The LLTNP, outdoor recreation and the “Master Plan” for Tarbet.

Tarbet Visitor Site Masterplan  
for Loch Lomond & The Trossachs  
National Park Authority  
December 2022

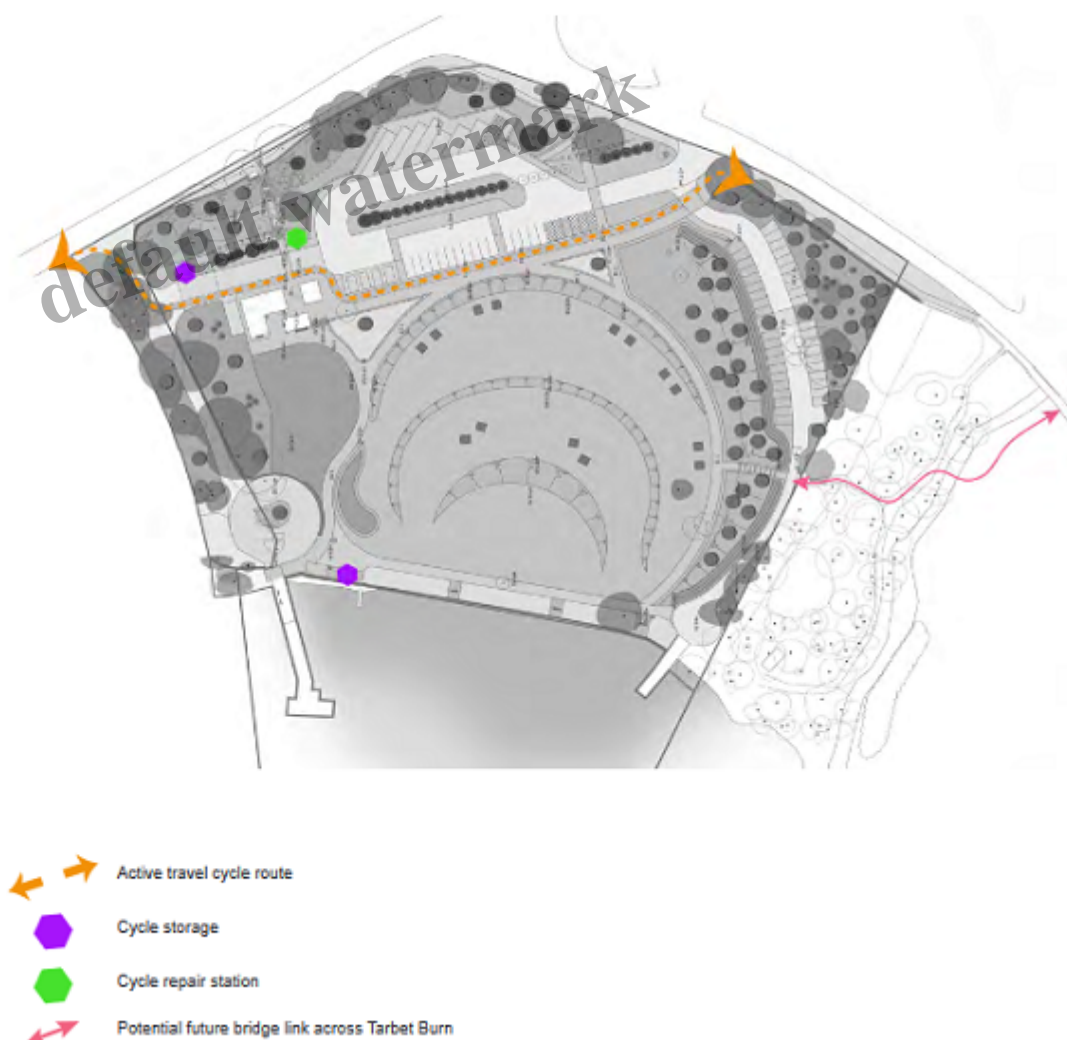
The cycle path highlighted in yellow on the masterplan, hugging the edge of the car park

The “Master Plan” appears to ignore these standards. The specified cycle is actually footpath width

(2m) not cycle path width and appears to continue at this width (or less), without a verge, north along the A82. This is completely unacceptable.

Where the cycle path crosses roads within the site and then the A82, before it follows the A83 up the hill to the station, there is neither protection nor indication that cyclists have precedence over motor vehicles. It appears the designers are unaware of government policy. Improving this route is a priority.

The extension of the cycle path north along the shore, built to Sustrans Design Standards, has been agreed by all and endorsed by the minister. To review these standards; the cycle path will be a minimum of 2.5m wide with a minimum 2.5m verge when alongside the road. If the path needs to cross a trunk road then cyclists will have to be protected by traffic lights or equivalent.

Having installed a much needed campervan waste disposal facility, the LLTNP now plans to direct campervans away from the site

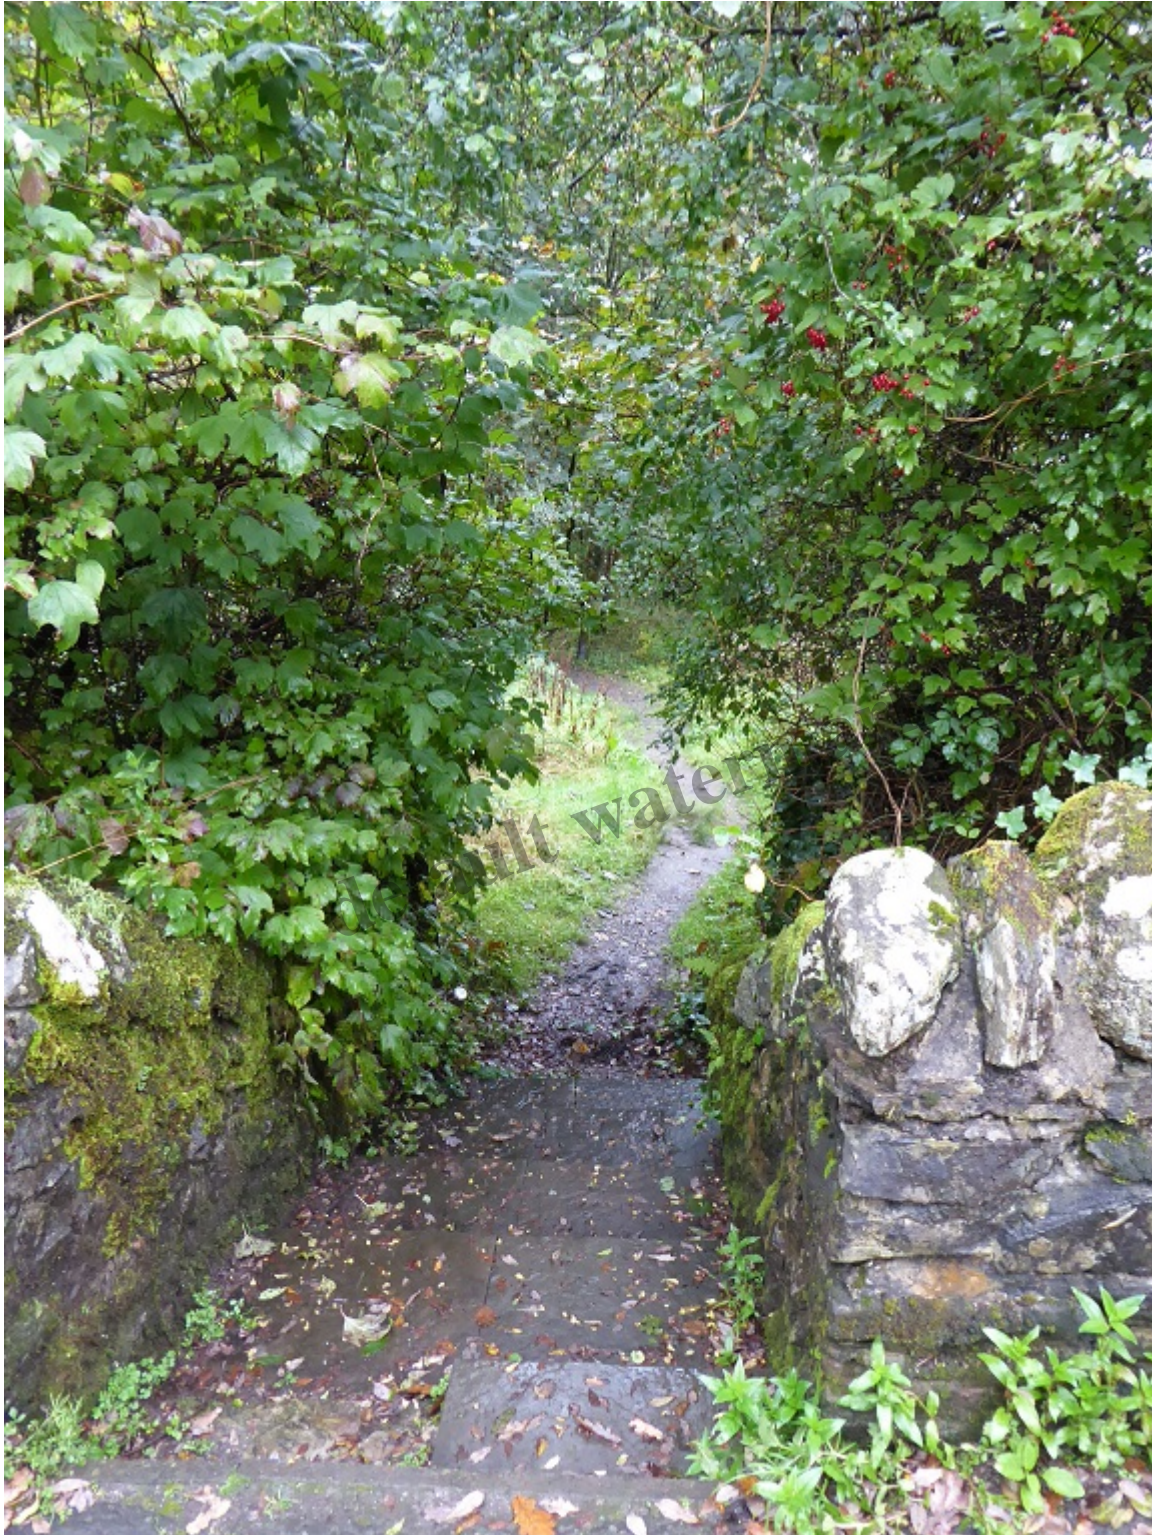
The reservation of a section of the car park in the masterplan for 4 Campervans is both inappropriate and inadequate and the decision to locate the much needed waste disposal facility at the Tarbet car park now appears a mistake.

The Park Authority should be looking to set up a minimum facility site for at least 20 vans and 20 family tents nearby. A suggested location is close to the station. Campervans should be encouraged not to overnight in lay-bys etc where there are no waste disposal facilities.
